## **COLLETON PLACE SUBDIVISION,** **PHASES 2-4**

APPLICATION NUMBER 1 DATE March 5, 2015

# DETAIL SITE PLAN

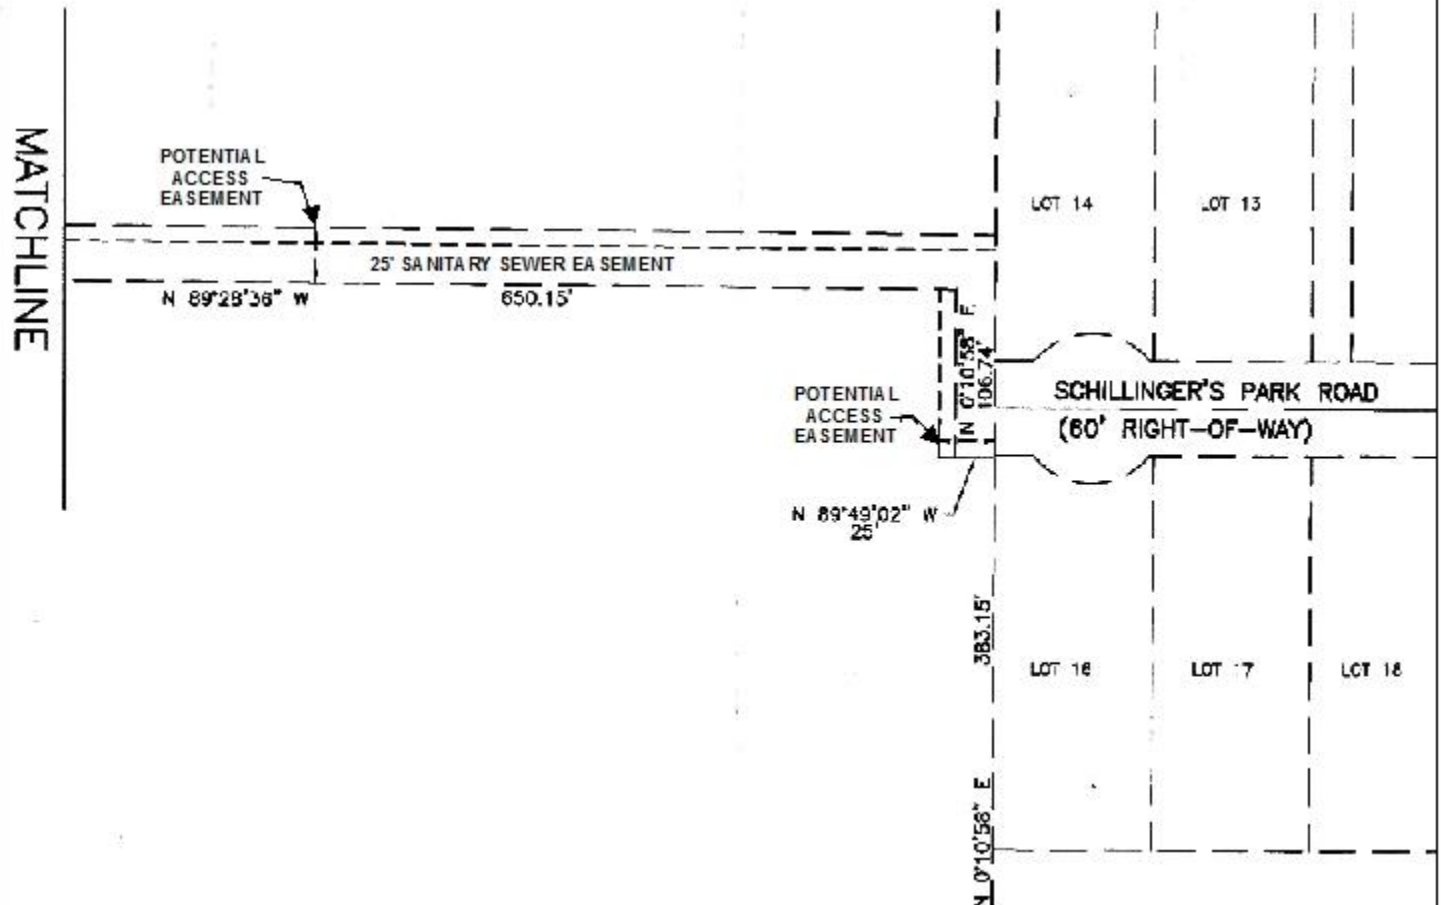
Not all of the proposed lots appear to comply with the minimum lot size requirements of the Subdivision Regulations, as 28 of the overall 104 new lots are proposed to be smaller than 7,200 sf. (the smallest lot would be 6,073 sf.) and, as such, would require a waiver of Section V.D.2. of the Subdivision Regulations for approval. Several lots would also require a waiver of Section V.D.3. of the Subdivision Regulations due to the extreme depth of the lots. The applicant also desires a reduced front yard setback of 20' and a side street setback of 15' – approval would require a waiver of Section V.D.9. of the Subdivision Regulations – citing the approval of Phase 1 as justification for a smaller lot size and reduced front yard setback. It should be pointed out that although a 20' setback is desired, the 16 proposed lots in Phase 2 appear to have a 25' minimum building setback as depicted on the preliminary plat. If approved, the Final Plat should be revised to illustrate the correct setback for all proposed lots.

The right-of-way width of all proposed streets within the subdivision is 50', as compliant with Section V.B.14. of the Subdivision Regulations. The plat also depicts a compliant 120' right-of-way width for all proposed cul-de-sacs; however, if approved, the provision of a temporary turnaround in compliance with Section V.D.6. of the Subdivision Regulations should be required at the terminus of Colleton Drive East prior to the signing of the Final Plat for each phase. All proposed streets must be built to Mobile County Engineering standards and be accepted by Mobile County prior to the signing of the Final Plat.

The applicant is proposing a mailbox kiosk and onsite parking with two curb-cuts for the proposed Lot 45 in Phase 3. As a means of access management, a note should be placed on the Final Plat limiting the proposed Lot 45 in Phase 3 to 2 curb-cuts and all other proposed lots in Phases 2-4 be limited to 1 curb-cut each, with the size, design and location to be approved by Mobile County Engineering and conform to AASHTO standards.

As mentioned previously in this report, the applicant is proposing a mailbox kiosk with onsite parking on the proposed lot 45 in Phase 3. As this site is located in the County, any lots which are developed commercially and adjoin residentially developed property must provide a buffer, in compliance with Section V.A.8. of the Subdivision Regulations. If approved, this note should be placed on the Final Plat along with the illustration of a residential buffer for the proposed Lot 45 in Phase 3 along the southern, western, and eastern lot lines.

Finally, the site is located within the City of Mobile's Fire Jurisdiction. While the existing Colleton Drive provides a stub-out to the South, and while the proposed Colleton Drive East is shown as providing a second stub-out to the South, the overall subdivision will only have one point of access for a total of 153 lots (existing plus proposed) until such time as the adjacent properties are developed.

- 1) The proposed additional phases will increase the number of lots within a subdivision that has only one point of access, thus the development will not comply with Section I.C.2. of the Subdivision Regulations, regarding Health and Safety;*
- 2) The subdivision, as proposed, will not comply with Section DI07.1 of Appendix D, of the 2009 International Fire Code, as adopted by the State Fire Marshal.*

*Although the applicant has outlined two possible solutions in the revised narrative, it appears that no revised plat was submitted to illustrate either resolution to depict compliance with Section I.C.2. of the Subdivision Regulations and Section D107.1. of Appendix D, of the 2009 International Fire Code. As such, the previous recommendation of denial should still stand.*

- 1) Revision of the Final Plat to illustrate a 20' minimum building setback for Phase 2 and retention of all other setbacks;
- 2) Retention of the lot size information;

- 3) Provision of a temporary turnaround in compliance with Section V.D.6. of the Subdivision Regulations at the terminus of Colleton Drive East prior to the signing of the Final Plat for each phase;

- 4) Provision of a residential buffer, in compliance with Section V.A.8. of the Subdivision Regulations, along the southern, western and eastern lot lines of Lot 45 in Phase 3;

- 8) Placement of a note on the Final Plat stating that Lot 45 in Phase 3 is limited to 2 curb-cuts, with the size, design and location to be approved by Mobile County Engineering and conform to AASHTO standards;

- 9) Placement of a note on the Final Plat stating that all lots (except Lot 45 in Phase 3) are limited to one curb-cut each, with the size, design and location to be approved by Mobile County Engineering and conform to AASHTO standards;
